PROPOSED CHANGE NO. SC-01-002R1

Date: July 24, 2025
File: 9.1.7.4.2_SC-01_PC
Project No.: 2215C
Project: TA Blakelock HS Reno - Phase 3
Subcontract: SC-01 General

Description: Elevator 2 (drama area)

CONTEMPLATED CHANGE NOTICE No. S1

1. ALL FRAMES AND SHORING JACKS TO BE PLUMB AND LEVEL.
2. SHORING JACKS TO BE DESIGNED BY THE SUPPLIER FOR THE LOADS AND HEIGHTS SHOWN, INCLUDING BRACING.
3. MAX. EXTENSION OF SCREWJACKS WILL BE 400mm UNLESS NOTED.
4. SCAFFOLDING SHALL BE ERECTED IN ACCORDANCE TO C.S.A. CODE S269.1.

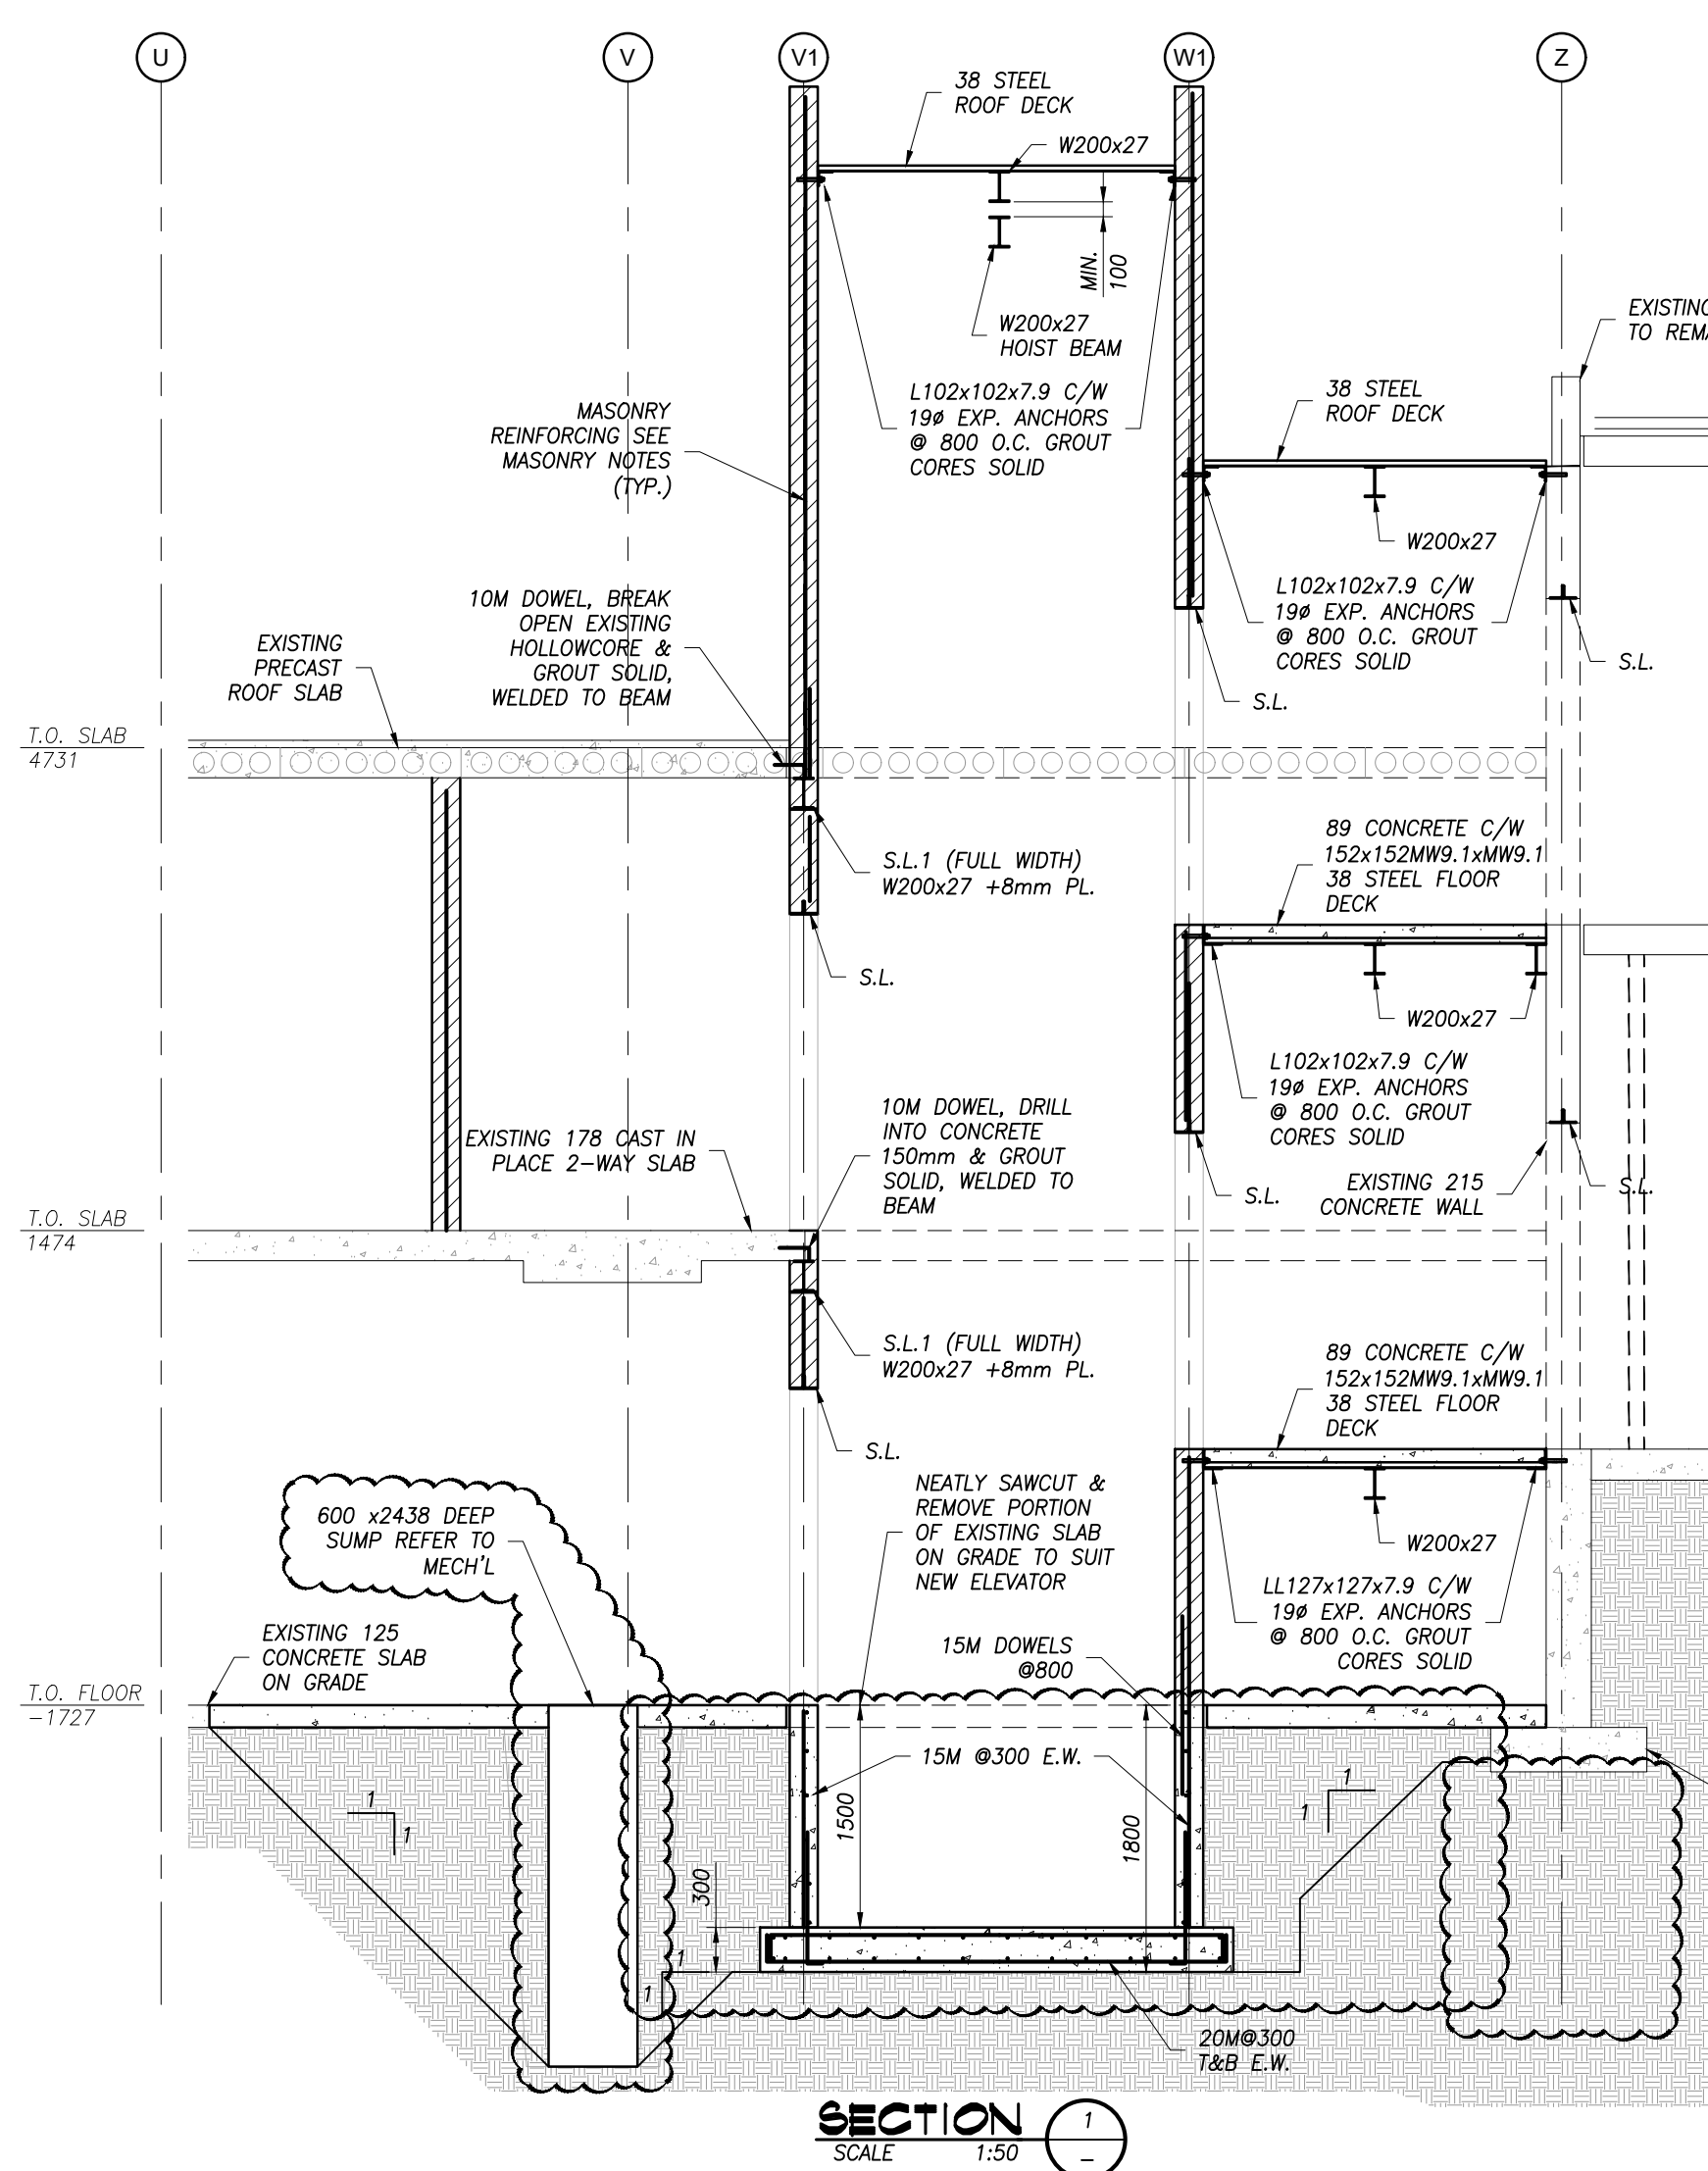
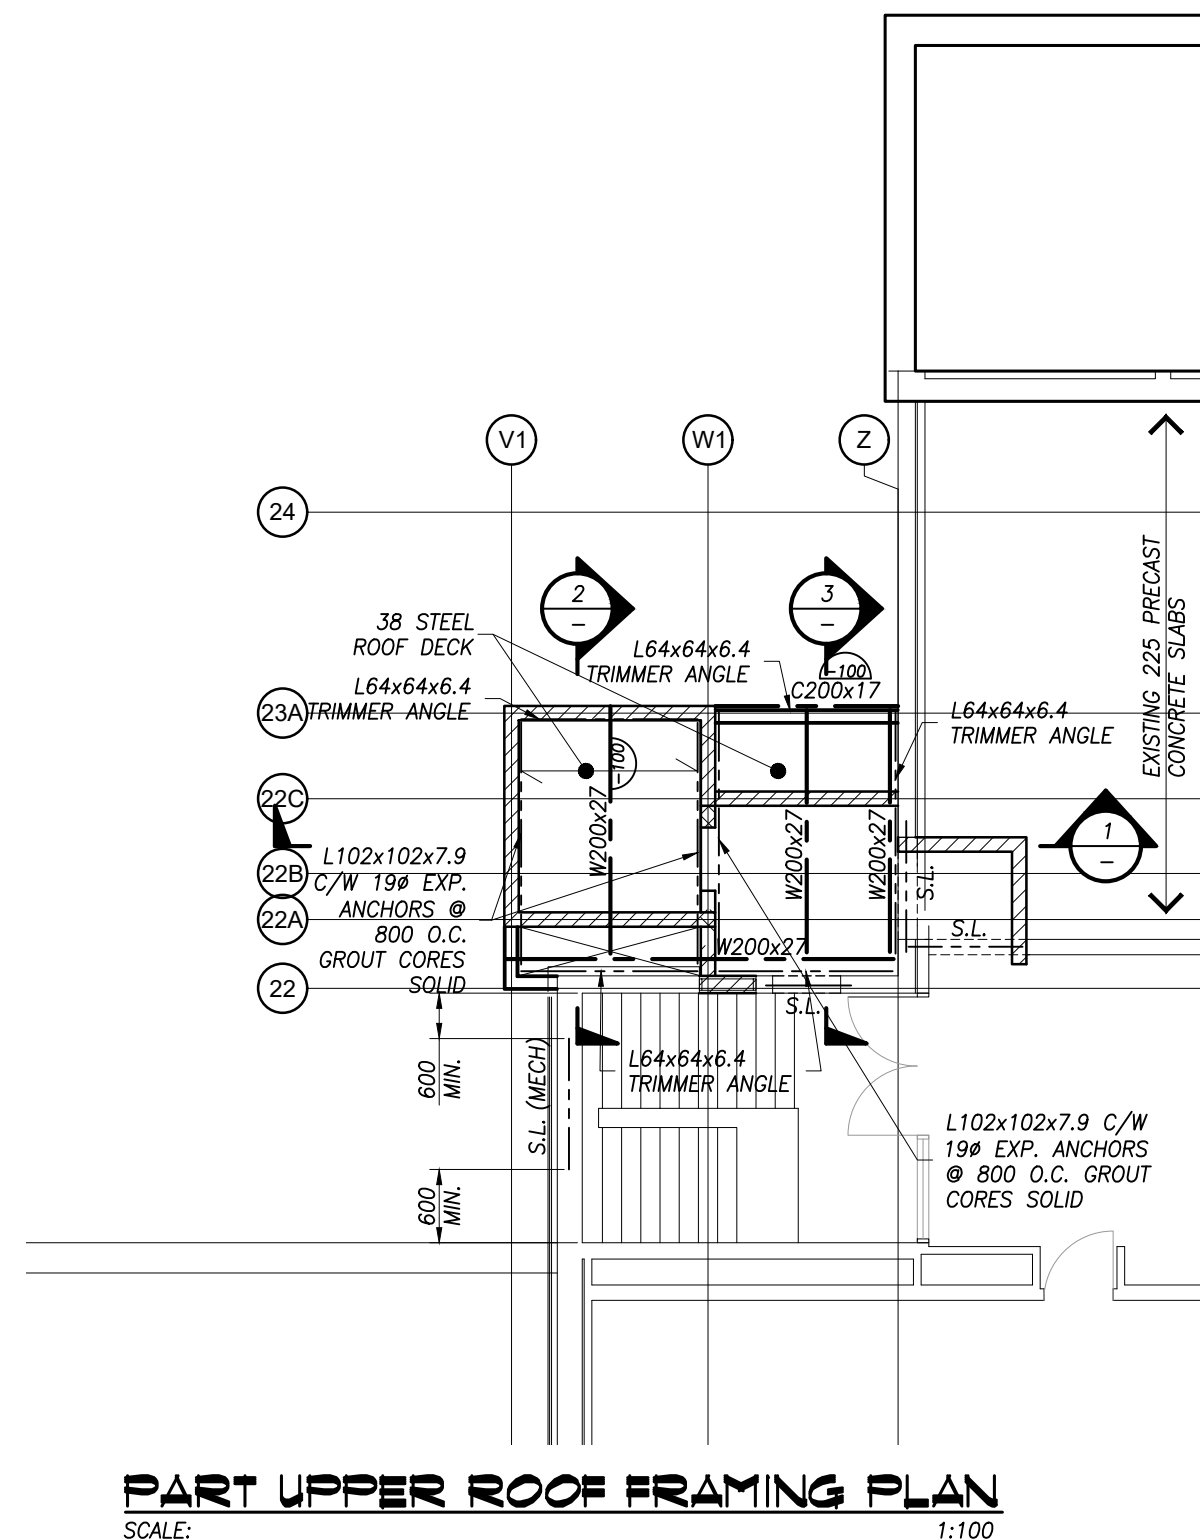
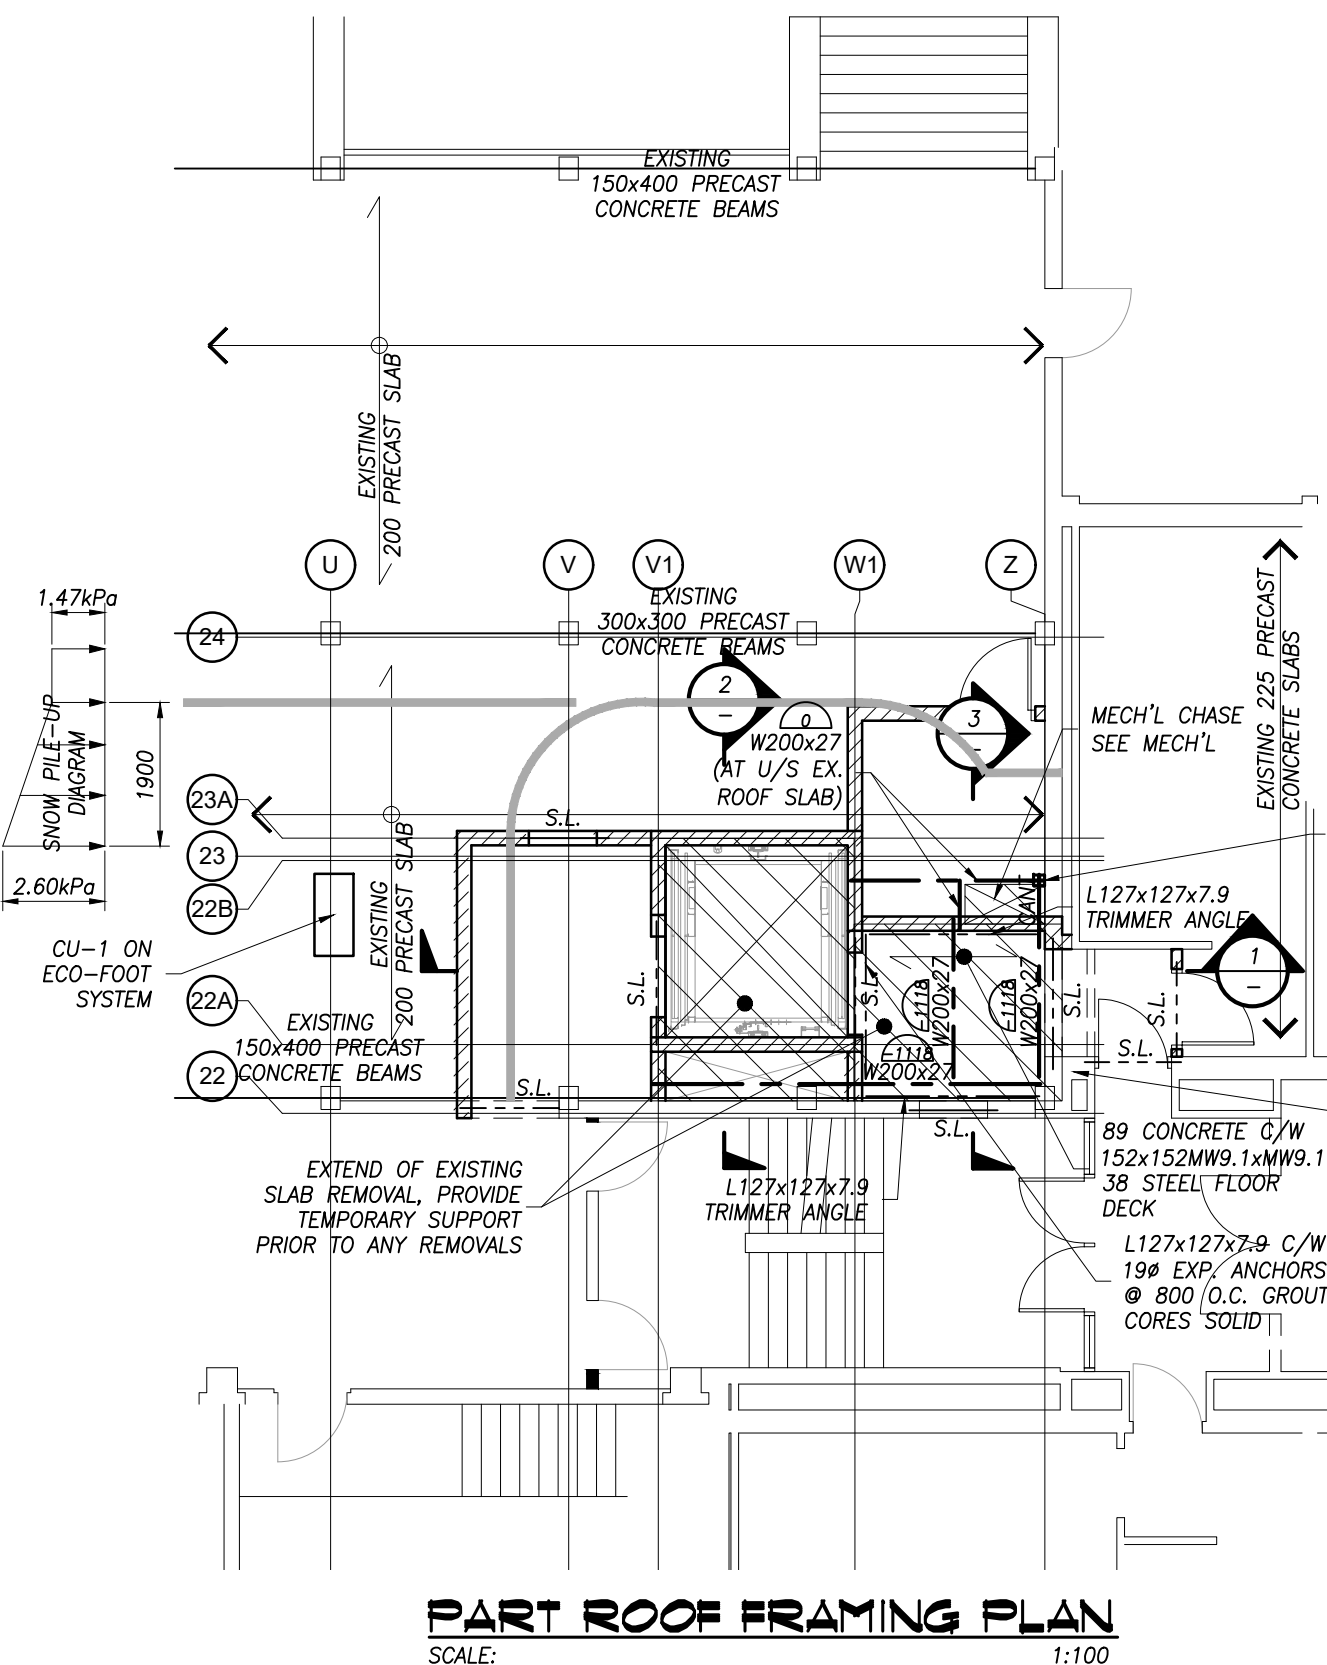
1. Underpinning extents and depths for Elevator 2 revised. Refer to updated drawing S300.
2. Foundation support for new column in Washroom Renovation revised. Refer to updated drawing S100.
